Subject: AP1000 Response to Request for Additional Information (SRP 3)

AP1000 TECHNICAL REPORT REVIEW

RAI Response Number: RAI-SRP3.7.1-SEB1-11
Revision: 3

RAI-SRP3.7.1-SEB1-11-10: Basemat Nodal Locations, Elevation 60.5'

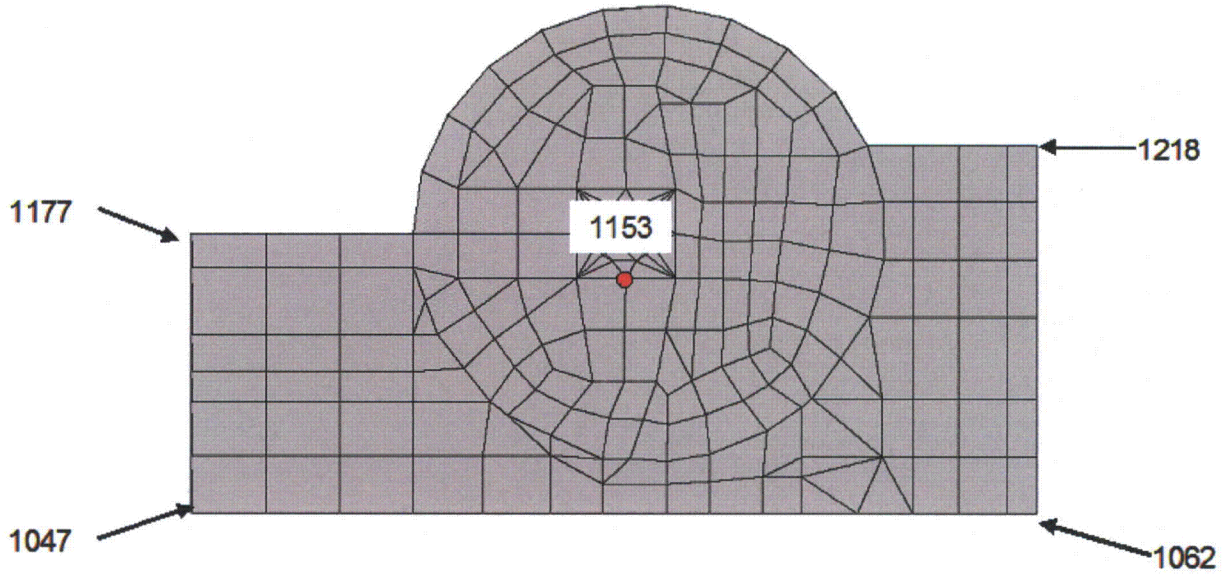
More data, i.e., HRHF response spectra for 5 locations on the basemat (4 locations at 4 corner and center) comparison of coherent at 5 nodes, 25 samples of incoherent and average of 25 incoherent response spectra.

Following the NRC Audit of AP1000 Seismic Design the week of April 13-17, 2009, the NRC has requested additional HRHF FRS at the four corners and center of the Nuclear Island basemat. The nodal locations of the response spectra comparisons have been provided in a plot shown in Figure RAI-SRP3.7.1-SEB1-11-10. A comparison of the SRSS combined X, Y and Z directions for incoherent simulations, average incoherent and coherent FRS are shown in Figures RAI-SRP3.7.1-SEB1-11-11 through RAI-SRP3.7.1-SEB1-11-25. The plots provided show a general reduction in the 25 incoherent simulations when compared to the coherent response in the higher frequencies. At lower elevations, the incoherent simulations exceed the coherent responses in the z-direction around the 10-20 Hz range; these exceedances do not exist at higher elevations as seen in Figures RAI-SRP3.7.1-SEB1-11-1 through RAI-SRP3.7.1-SEB1-11-9.

Figure RAI-SRP3.7.1-SEB1-11-32: Transfer Function Node 1761 X-Dir

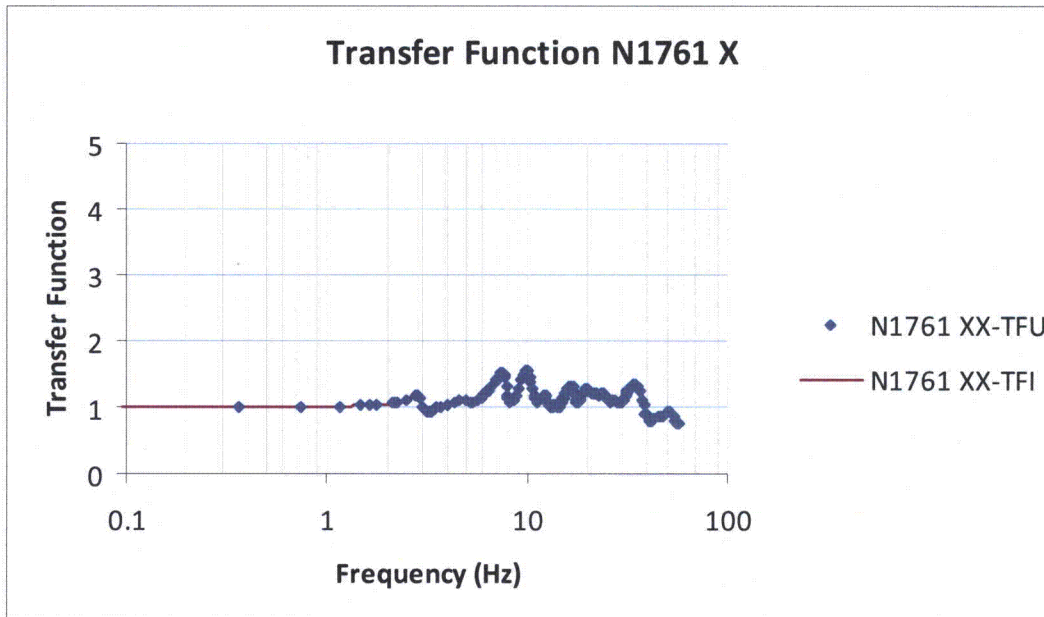
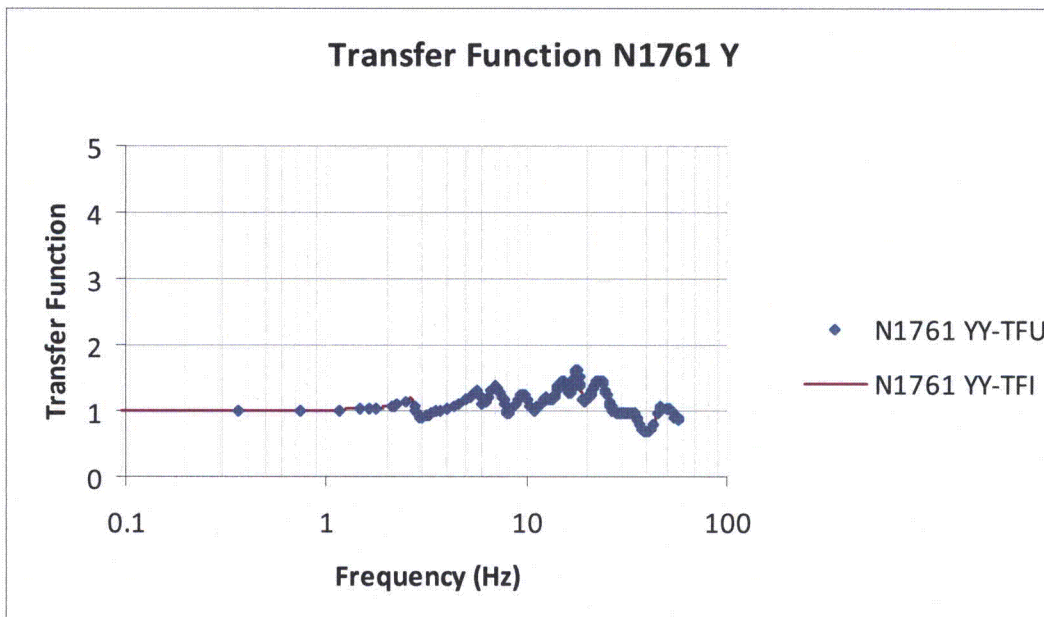
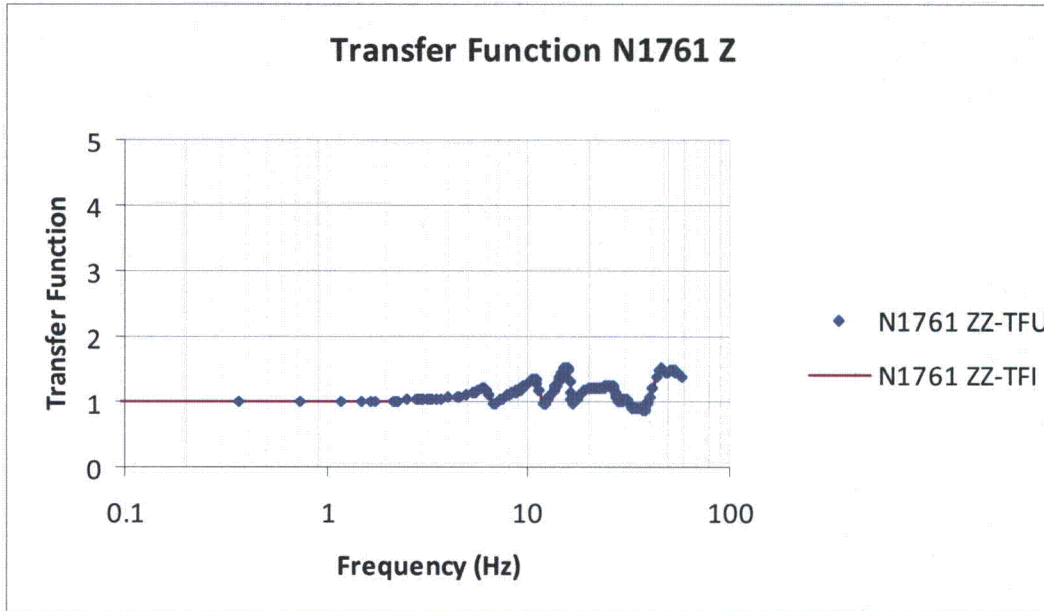
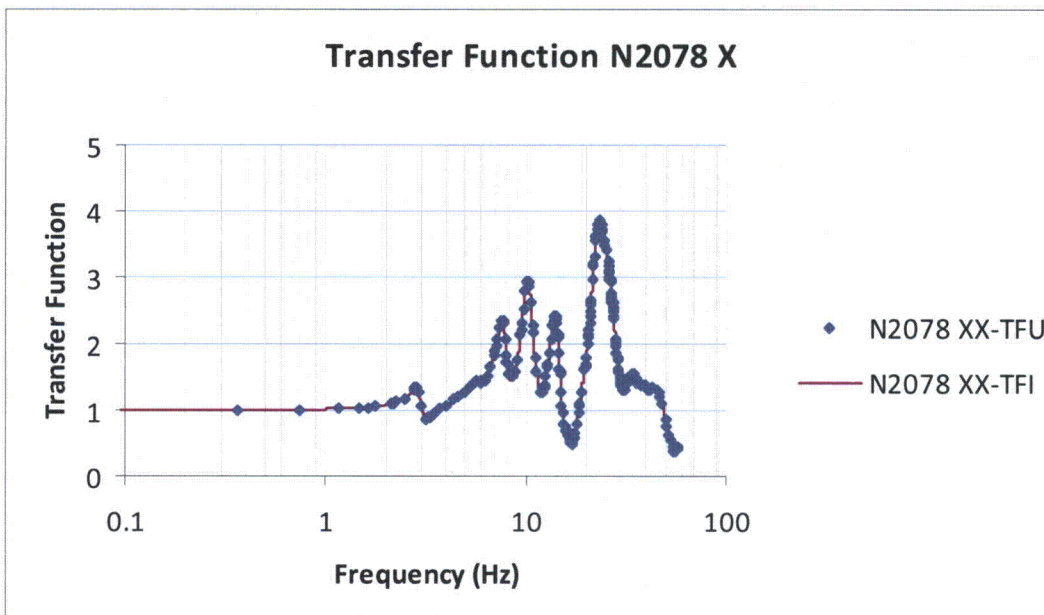
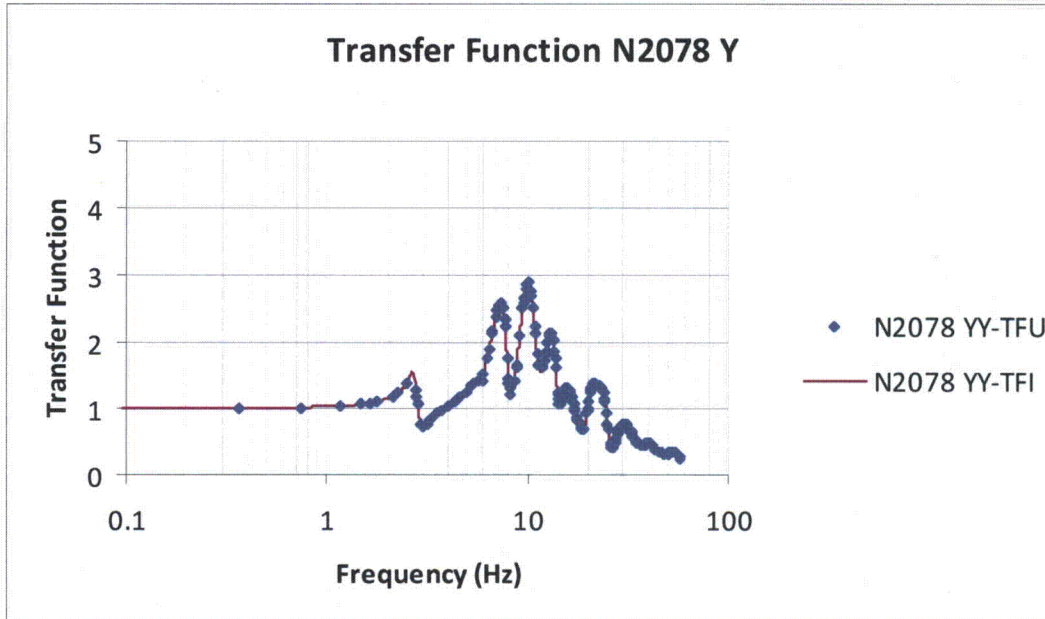
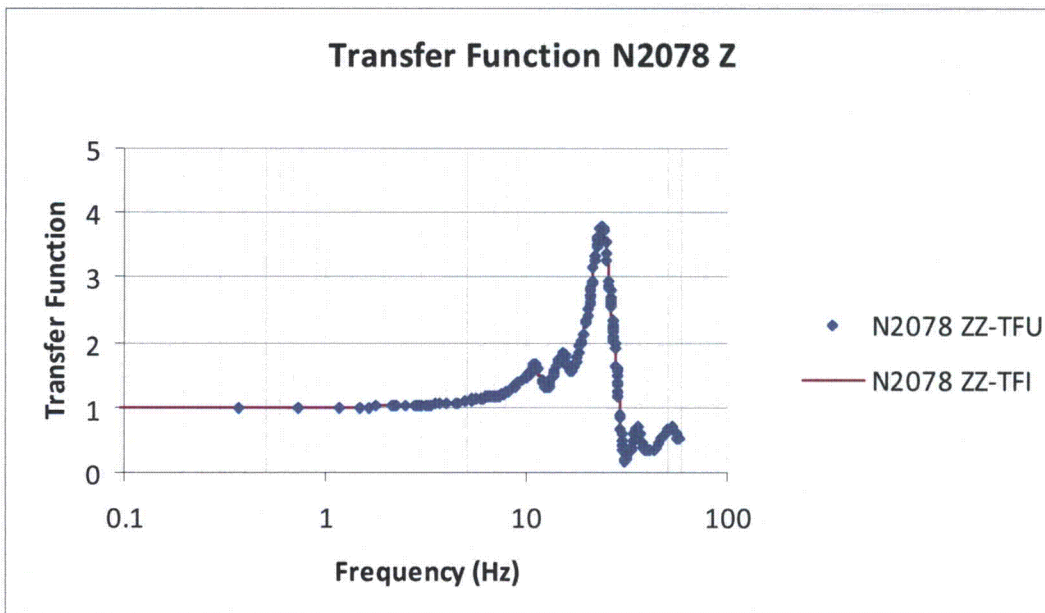
- A. Westinghouse will revise analysis to correct boundary conditions of rigid beams to solid elements in the NI20 SASSI model.
- B. Westinghouse will evaluate the need of modifying the transition shell to brick interface.
- C. Review interpolation function for NI20 SASSI model.
- D. Reanalysis of seismic response will correct/clarify values and results will be re-issued as a new revision to RAI-SRP3.7.1-SEB1-11.

C. Westinghouse manually checks the interpolation function for the NI20 model to ensure the correct starting point of one for the transfer functions. The interpolation function for the six key locations is shown in Figures RAI-SRP3.7.1-SEB1-11-32 through RAI-SRP3.7.1-SEB1-11-

49. Note that in these figures, XX-TFU and XX-TFI indicates the coherent transfer function TFU and coherent transfer function TFI, respectively
